Sent: 30/08/2019 7:48:15 PM
Subject: Submission in relation to DA2019/0811
Attachments: DA20190811 submission.pdf;

RE: DA2019/0811 – New Seniors Housing Units with Basement Parking Development Application at 49 Forest Way, FRENCHS FOREST NSW 2086

Proposed development appears 2.5 storeys high due to breach of 7.2m wall height plane and façade length to Adams Street is excessive

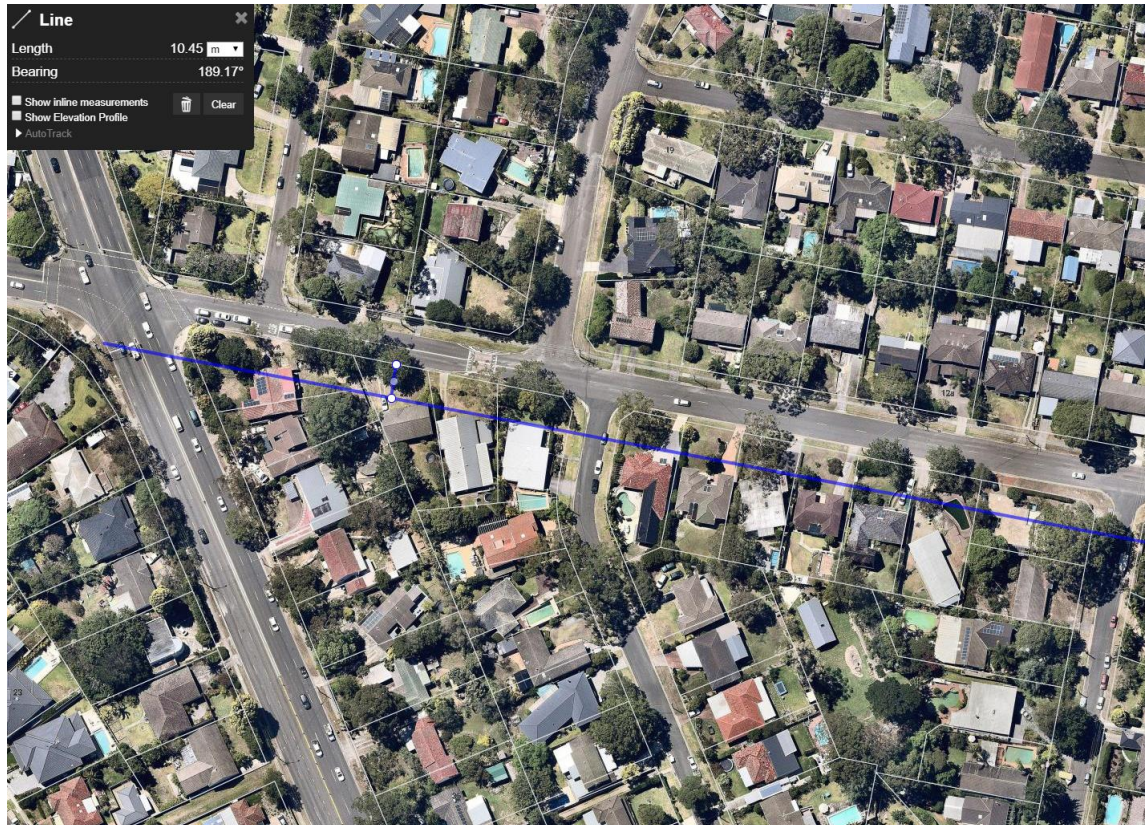
The proposed development being located on an elevated corner block is visually prominent and will have the appearance of a multi-unit residential development with long facades to the Adams Street frontage and a two and a half storey appearance when viewed from the east due to excessive height which breaches DCP wall height plane. The height will dominate our single storey residence to the east and the balconies overlook our bedroom window and terrace. The existing 49 Forest Way residence has a façade length of 11m to Adams Street and the proposal is approximately 33m or three times the existing proportion.

The proposed setback of 3.5m to the 33m length of Adams Street frontage is very out of character with the existing front setbacks along Adams Street – shown below to be in the order of 10m on average. The 3.5m setback control proposed is for domestic scaled houses on corner allotments. The proposal will dominate the visual character of Adams Street and this will be exacerbated by its two and a half storey appearance viewed from the east approach.

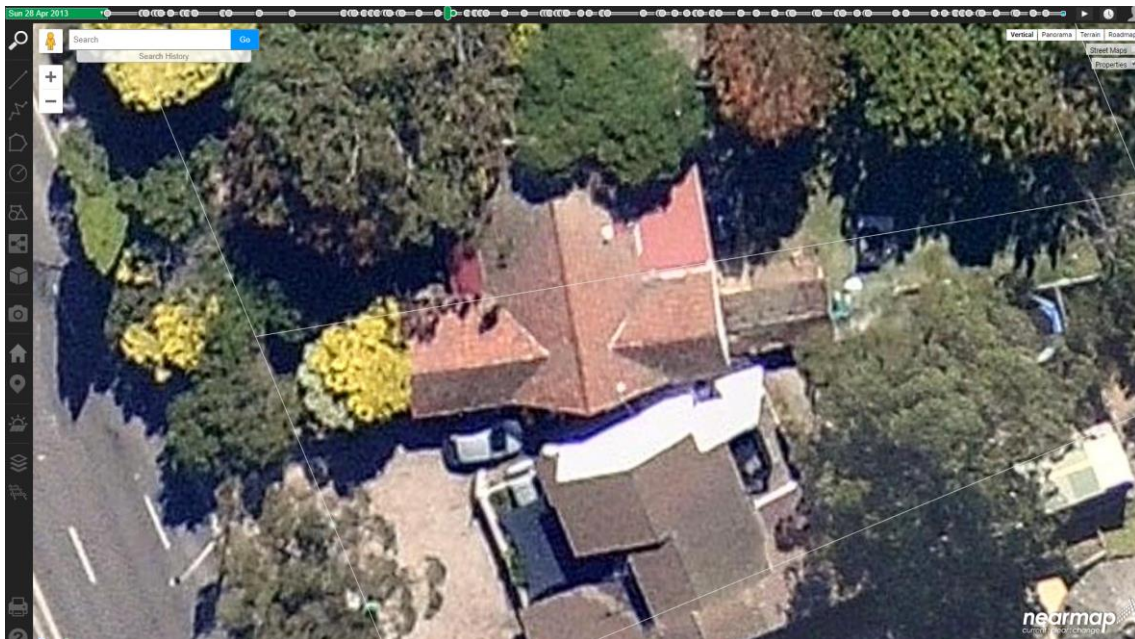
A large development of this nature should include a detailed acoustic report to ensure the appropriate noise levels from the proposal does not affect the amenity of neighbouring dwellings. As stated above our master bedroom window is orientated in such a direction that there is a direct line of sight between the balconies and living areas of the proposal and our bedroom. Also of significant concern is the position of driveway ramp again which will mean vehicles entering and exiting the property and accelerating up the driveway ramp will cause a significant new noise source to our master bedroom potentially at all hours of the day. We will also have to content with headlights shining through our windows as cars enter the driveway. Having lived in an apartment complex previously we are all too familiar with this noise source as well as the opening and closing of security doors. Our boundary fence is a heavily dilapidated timber fence and will provide little to no acoustic buffering from the elevated balcony of the proposal or the driveway.

The BASIX certificate notes that the living areas and bedrooms will be provided with air-conditioning. The basement carpark will also require ventilation and neither the air-conditioning nor the ventilation plant have been detailed in location or type in the drawings. Both of these items will potentially be a significant noise source particularly through summer when we leave our master bedroom windows open for passive ventilation.

Council should insist that a detailed acoustic report be undertaken including noise logging and a specification of the location and indicative selection of all mechanical plant equipment should be provided to ensure that there is no exceedance of background noise levels.

47 & 49 Forest Way 28 April approximately Midday (and equinox) – note that the east façade of 47 Forest Way is enjoying full solar access due to its ENE orientation, and the backyard immediately outside rear façade of 47 Forest Way is also in full sun – image courtesy of Nearmap

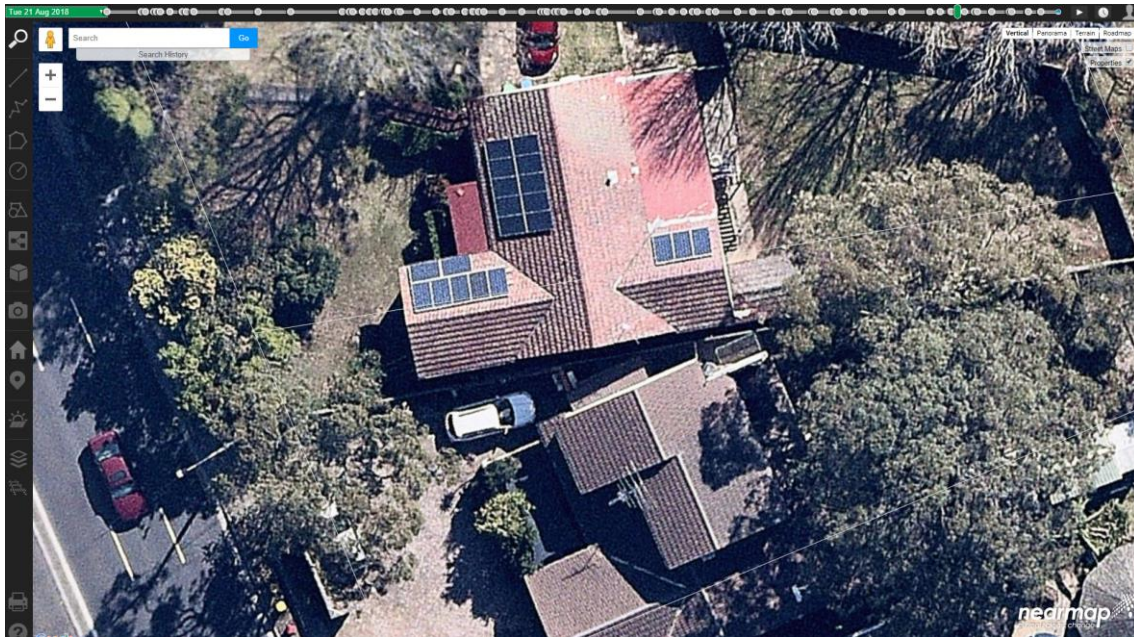
The application purports that there is no impact on 47 Forest Way as they do not have any windows in their north façade. Rather than ameliorating an impact this substantially increases the impact of the development as 47 Forest Way is so heavily reliant on mid-morning to early afternoon sun to achieve acceptable light into their ENE facing windows and backyard (refer image sequence below). The submitted Clause 4.6 for variance to the 25% rear area single storey SEPP control states on Page 8 that 47 Forest Way will still receive 3 hours of sun to their property. This claim is erroneous and fails to consider when sunlight is actually able to be received into their windows (10am – 1pm) due to the large trees that shade the walls in early morning. In any case the development is already causing substantial overshadowing by 12pm onto the ENE façade and even without the trees being present it is not correct to say that 3 hours of sunlight has been achieved between 9am-12pm as is required.

The extent of impact on 47 Forest Way could be substantially improved if the development complied with the required 25% of rear site area being single storey as mandated by the SEPP. The submitted Clause 4.6 cannot substantiate that there is no impact to 47 Forest Way in relation to overshadowing for the above reasons. Indeed the non compliance with the control means overshadowing extends all the way into the back yard of 45 Forest Way as well. There is clearly a significant loss of sunlight and amenity which is unacceptable. At a minimum the applicant should be required to provide a solar study on the façade and rear private open space of 47 Forest Way at one hour increments proving that 3 hours of sunlight is maintained to their premises – which will show that the assertions made are false and the setbacks are inadequate.

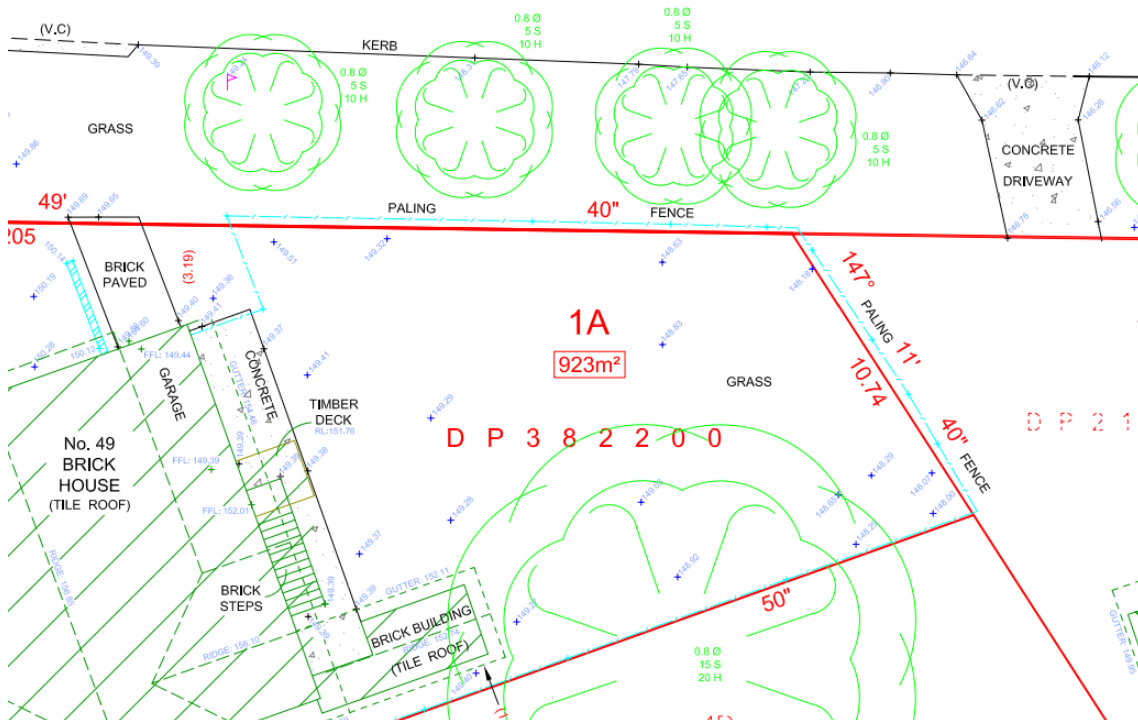
The accessible car spaces proposed are non-compliant with AS1428.1.

Given that the development is trying to leverage the SEPP for seniors living and people with a disability this seems to be a fairly critical oversight. Accessible car parking bays should have a minimum dimension of 2.4m width and 5.5m length and have a shared space of the same dimension immediately adjacent and unencumbered by other parking bays, line marked appropriately and protected with a bollard. They should have a minimum height of 2.4m immediately above the spaces for loading and unloading of a wheelchair as well as a clear path of travel to the car space of 2.4m height. I note that a floor to floor height of only 2800mm is proposed which is very tight for a basement carpark that needs to have accessible spaces. Given the large spans of the suspended concrete ground floor slab in all likelihood then there will be locations where beams will reduce effective ceiling height down to less than the required 2400mm clearance height, and this is even before any consideration of plumbing services or the mechanical exhaust ducts. I am dubious that the spaces can comply in the current configuration without either raising the ground floor slab (exacerbating height and overshadowing non-compliances) or lowering the basement level (potentially requiring increased driveway ramp length or compounding current slope non-compliance). What this demonstrates is the unsuitability of this site to take a development of this intensity. The applicant should provide revised plans and detailed sections showing how compliance with standards will be achieved. Manoeuvring within the basement carpark also looks problematic especially for the western most car space which does not appear to have sufficient clearance for an end bay.

Council should require amended carpark design, the traffic report should be amended to show vehicle turning circles.

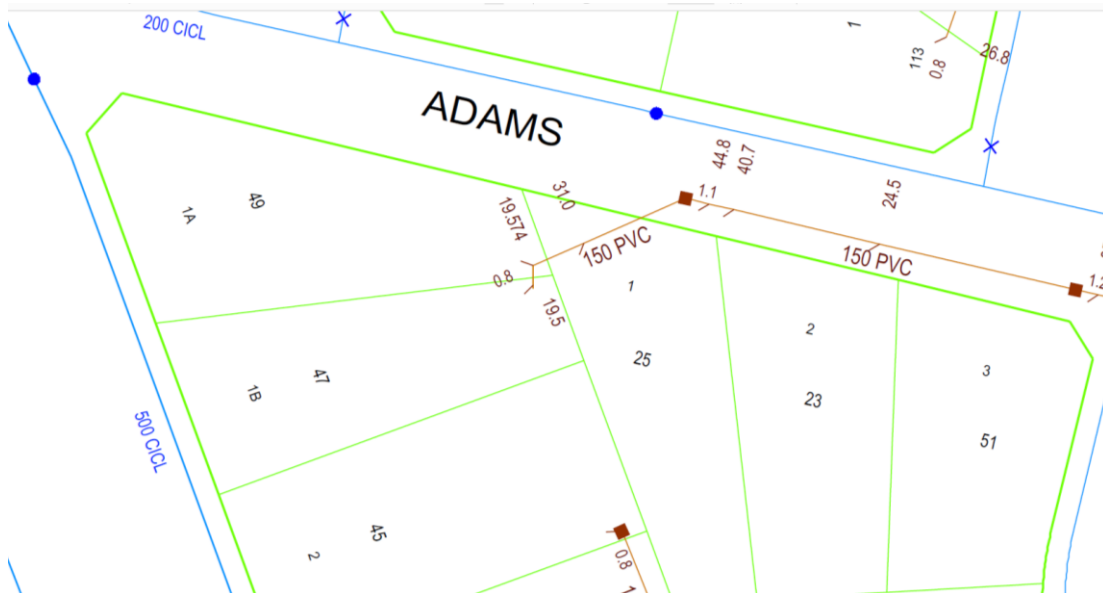
The development will increase stormwater discharge into our property and Adams Street and add to localised flooding issues.

Our property already receives substantial overland flow in heavy rain events from 49 Forest Way. I also note that the stormwater line that connects 49 Forest Way to the kerb line occurs directly adjacent to our driveway (I believe actually cutting across the front corner of our property although no easement exists) and appears to have broken as the ground immediately to the west of our driveway above this outlet becomes sodden with even light rain indicating broken pipework. The new development tries to avoid providing on site detention because of some small rainwater tanks provided. These rainwater tanks will be of no use in preventing overland flows in heavy rain when the small kerb outlets back up and tanks are already full. Frenchs Forest is one of the wettest suburbs in Sydney and the issues to our property are insignificant compared with the flooding that occurs lower down Adams Street.

It is completely unacceptable that with such intensification of roof area and hard paved surfaces that this development provide no OSD and Council should enforce compliance with their OSD requirements.
